As-Built Baseline Monitoring Report

MONKEY WALL PROJECT

NCDMS Project #100069 (Contract #7536)
USACE Action ID: 2018-01162
DWR Project #20181029

RE: Monkey Wall Site: Baseline Report and As-Built Drawings (NCDMS ID 100069)

As-built Credit Adjustment
Monkey Wall
Mitchell County, North Carolina

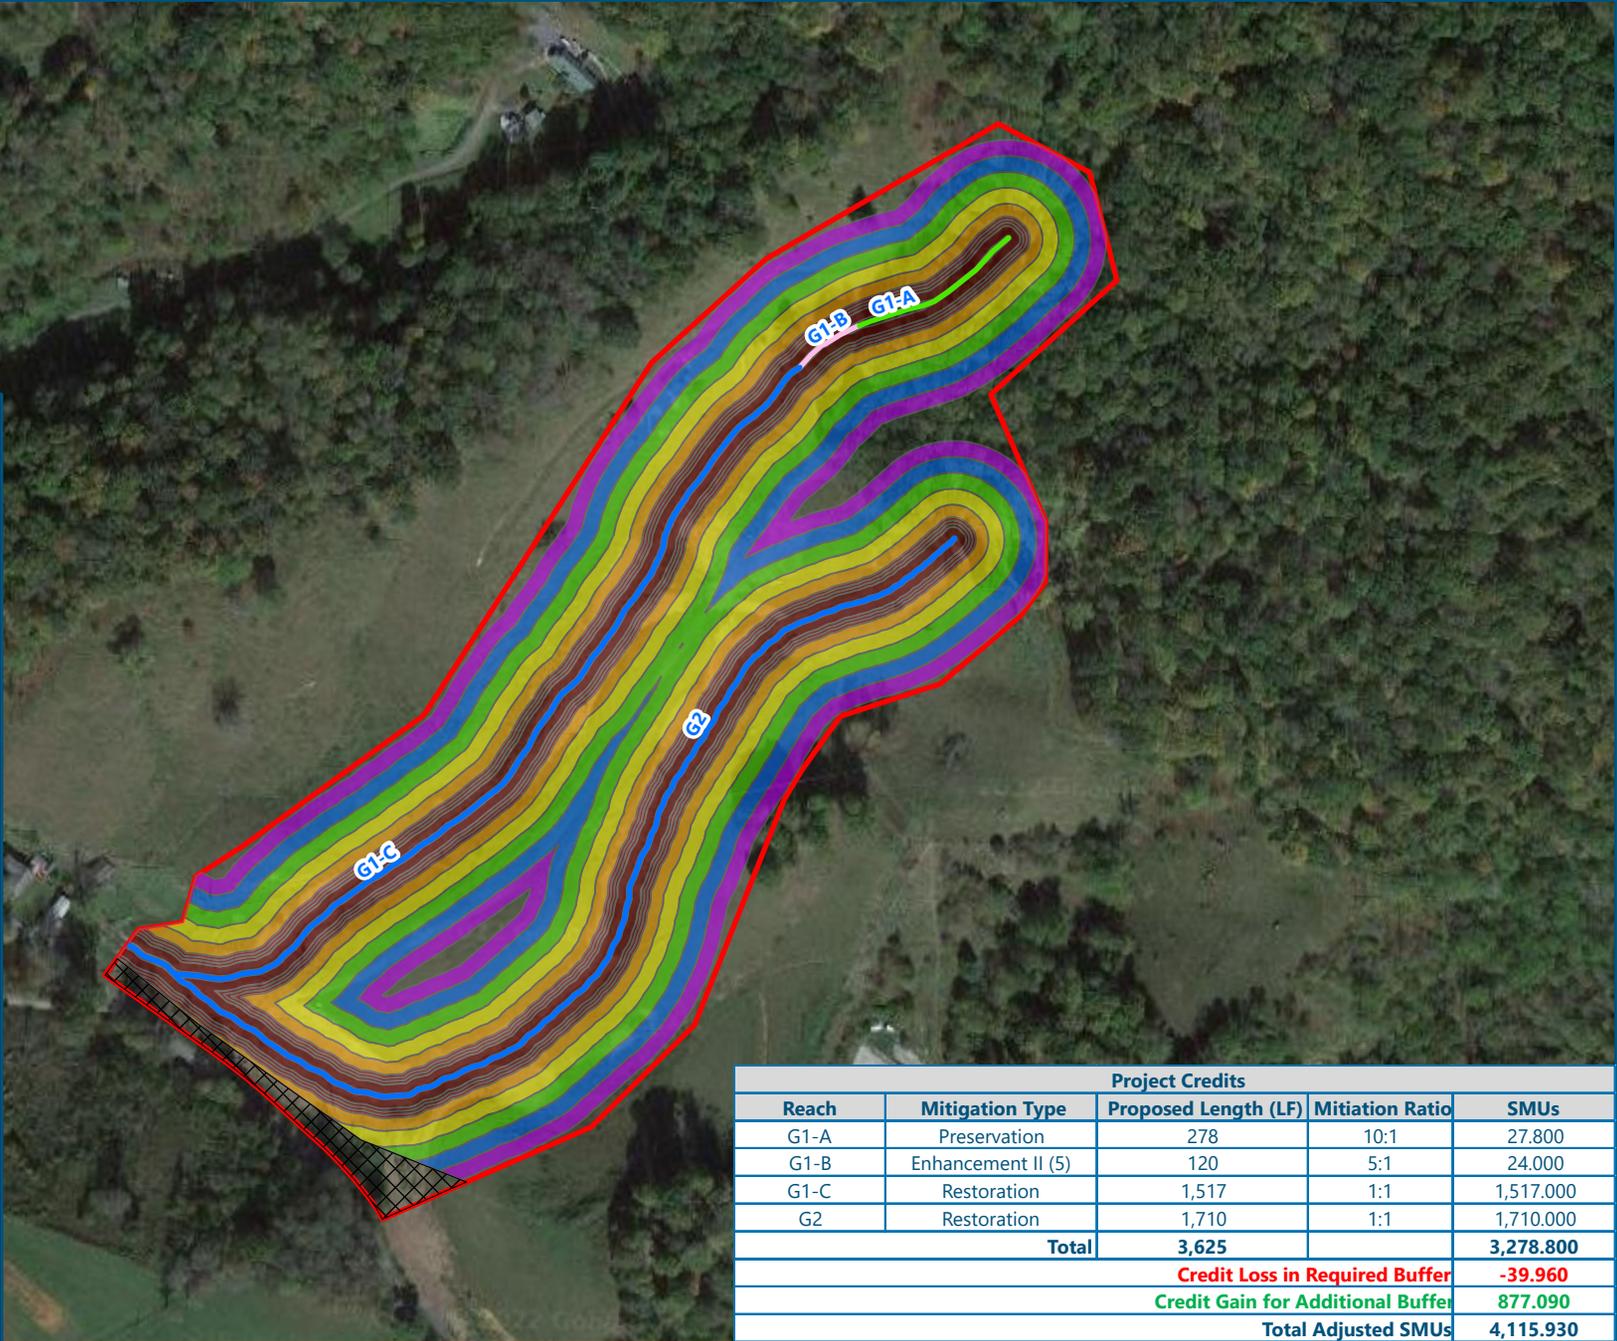
Through stream restoration, enhancement, and preservation, the Monkey Wall Project presents 4,115.930 Cold Stream Mitigation Units (SMU) at As-Built. An additional 241.461 SMU were generated by relocating the utility lines that intersected the project through the center of the conservation easement to the southern boundary of the easement.

Attached is the updated USACE non-standard buffer width calculation spreadsheet and map, and credit table. The abandoned and new utility alignments can be seen on Sheet A1 of the project Record Drawings (Appendix E).

DRAWING TITLE:
OVERVIEW

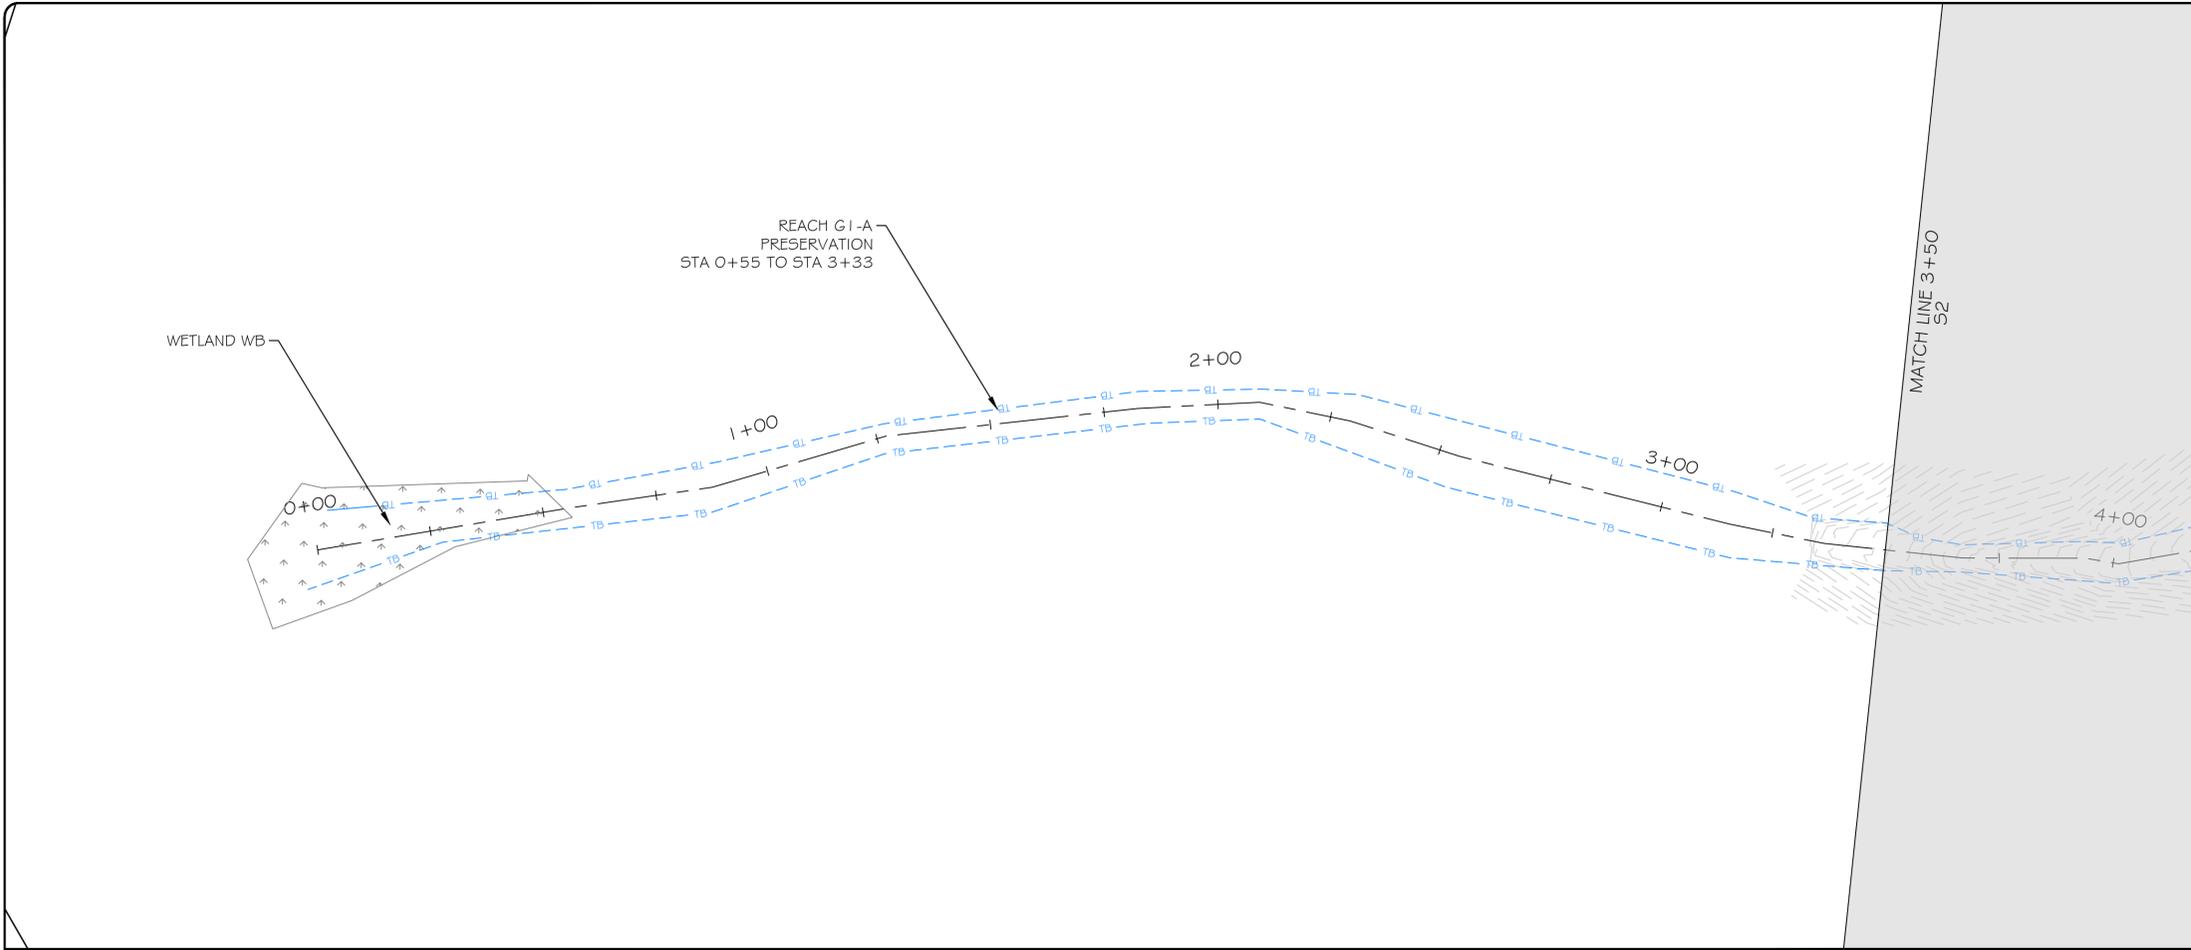
The overhead utilities included lines from French Broad Electric and Country Cablevision. French Broad Electric relocated the powerline in April 2022 and Country Cablevision (Zito Media) moved their fiberoptic cable line in October 2022. RES removed the old utility poles in October 2022. RES recalculated the USACE non-standard buffer width using the new utility line location surveyed by Ascension Land Surveying in July 2022 which resulted in a credit loss in required buffer of 39.960 and a credit gain for additional buffer of 877.090. Stewardship has agreed to allow the utility line to remain inside of the conservation easement as a special management area.
